October 30, 2020
E-57412

Subject: Additional Information for Application for Revision 5 of Certificate of Compliance No. 9358 for the Model No. TN-LC, Docket No. 71-9358 (EPID No. L-2020-LLA-0086)

RAI 1-1:

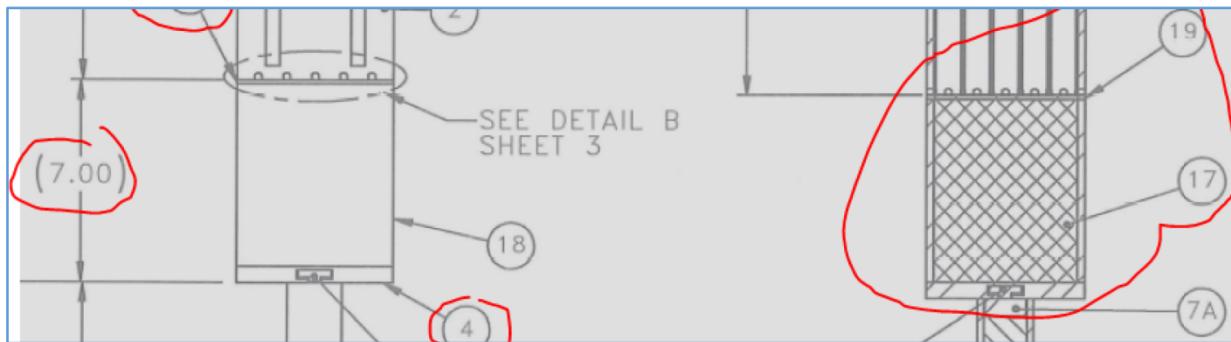
Confirm that the thicknesses of the top lead gamma shield and the bottom lead gamma shield in the proposed drawing revisions for the Option 3 pin can basket in Drawing No. 65200-71-102 are unchanged.

It is not clear from the previous and current drawing revisions if and how the dimensions related to the thicknesses of the lead gamma shield components of the Option 3 pin can basket have changed. This is unclear since some dimensions are not given and others show only as reference dimensions in both the currently approved drawing revision and the proposed drawing revision for the pin can. Also, as discussed in the application, a variety of changes were made to the drawings including this one; however, as stated in the revision description on this drawing, no revision marks are provided.

Response to RAI 1-1:Bottom lead gamma shield thickness - pin can option 3:

For information, the thicknesses of items 4 and 19 are 0.56" and 0.13" respectively. Hence, the thickness of lead is $7.00 - 0.13 - 0.56 = 6.31"$. This is the same as what is given on new Drawing 65200-71-102, sheet 4, detail 2: the thickness of the bottom lead gamma shield component of the Option 3 pin can basket has not changed.

For information, the as-fabricated bottom lead thickness was measured between 6.31" and 6.32".

At the top of the cask:

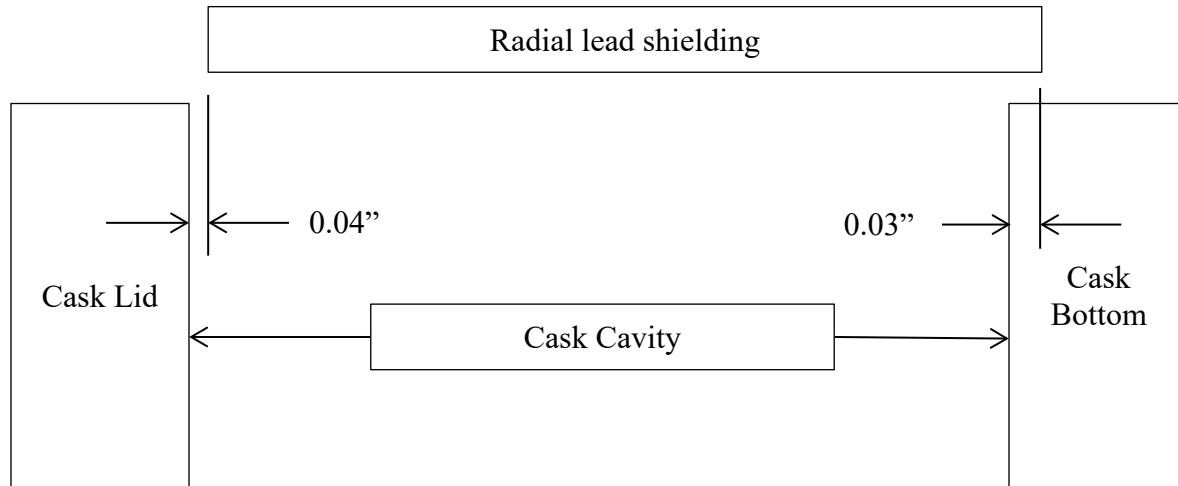
It is not clear whether the change in packaging cavity length is or is not the result of changes that also affect the axial extent and positioning of the radial lead gamma shield and neutron shield. Changes to these aspects of the shielding components could affect the shielding performance of the package that is described and analyzed in the application for the Unit 01 packaging.

As explained in the response to RAI 1-4, the radial lead shield length is meant to coincide with the length of the cask cavity.

It was verified using as-fabricated dimensions that for Unit 01, despite this unit's cavity length being out of tolerances and slightly shorter than expected, the radial lead shielding starts less than 0.04 inches below the lid surface at the top of the cask, and extends at least 0.03 inch past the bottom of the cavity at the bottom of the cask (shown in the sketch below, with exaggerated scale for clarity). This analysis is described further in the details below, and its results are in line with the design intent stated above.

Per the cask as-built records, the radial lead shielding starts between 7.47 and 7.48 inches from the top surface of the top cask flange. The cask lid bottom surface (which delineates the top of the cask cavity) is located between 7.44 and 7.46 inches from the top surface of the top cask flange. Therefore, the radial lead shielding starts, at worst, $7.48-7.44=0.04$ inches below the cask lid bottom surface (meaning no more than 0.04 inches of the cavity extend past, and is uncovered by, the radial lead shielding at the top of the cavity).
